Joint Local Authorities Group (JLAG) engagement event with Town and Parish Councils, 26/7/2019

Sizewell C Stage 4 Consultation

EDF Energy Stage 4 Proposals

Pylons

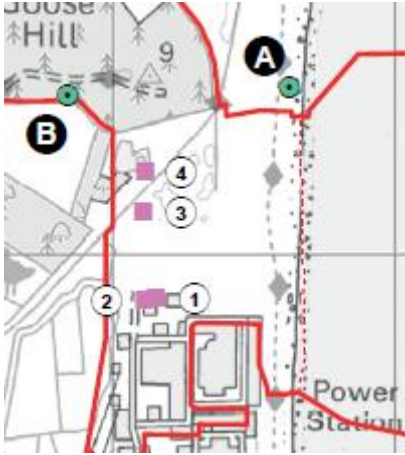
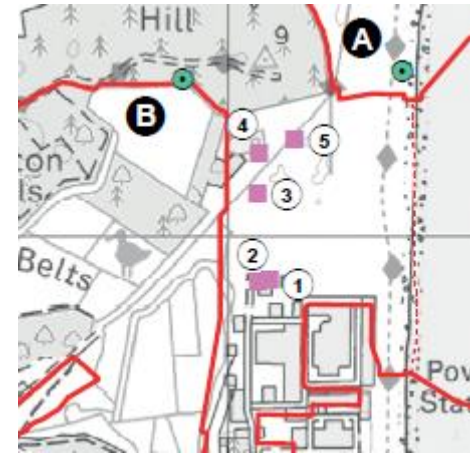
Option 1: 4 pylons, 3 reduced in height by 25 % (document does not state actual heights)
Most prominent northern pylon “4” full height

Option 2: 5 pylons, all reduced in height by 25 % (document does not state actual heights)

Fen Meadow mitigation for loss at SSSI

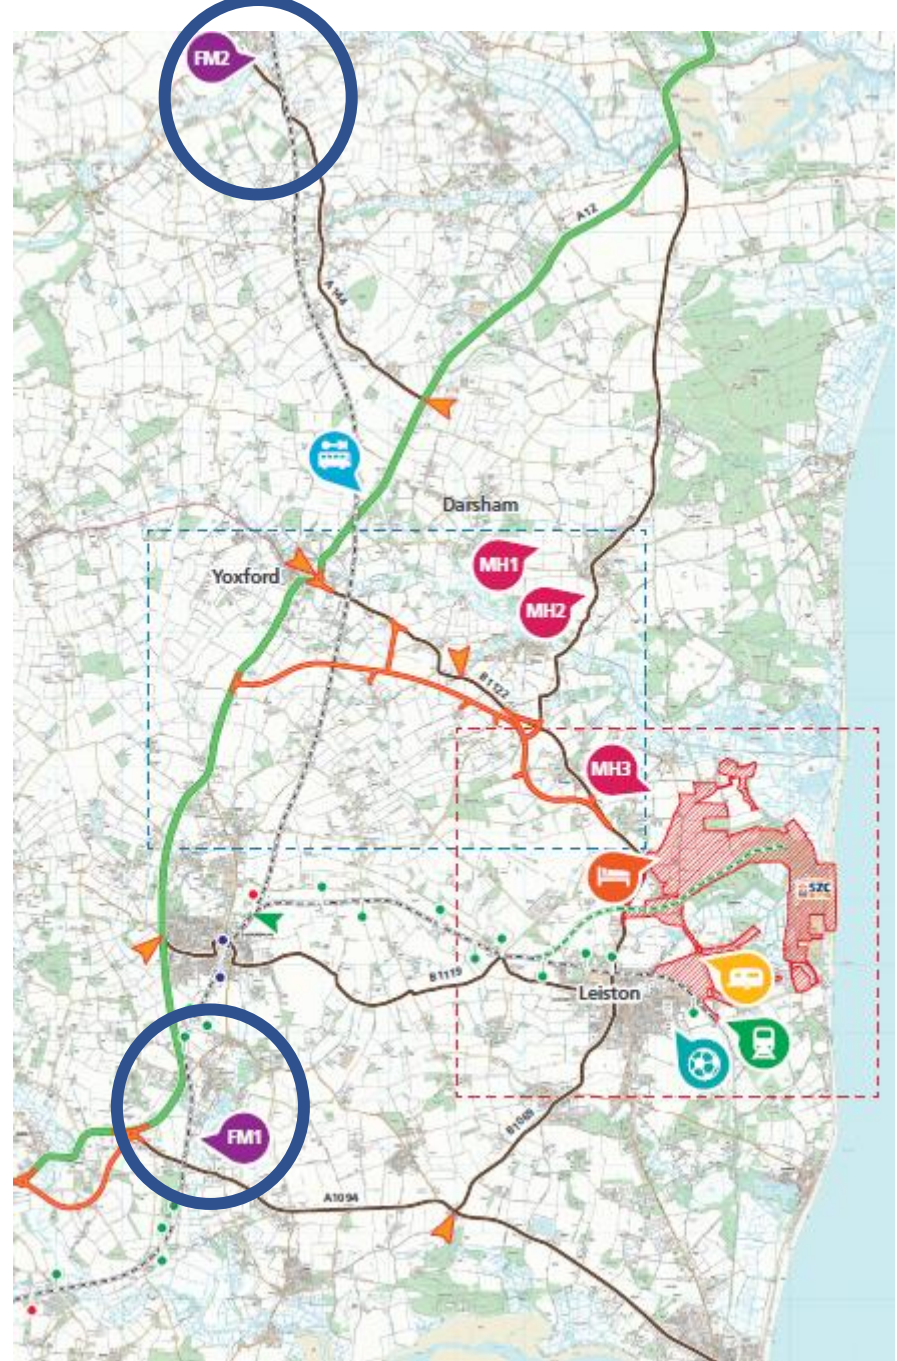
- Riverside between Benhall and A1094.
- Site East of Halesworth (A144/Blyth Road).
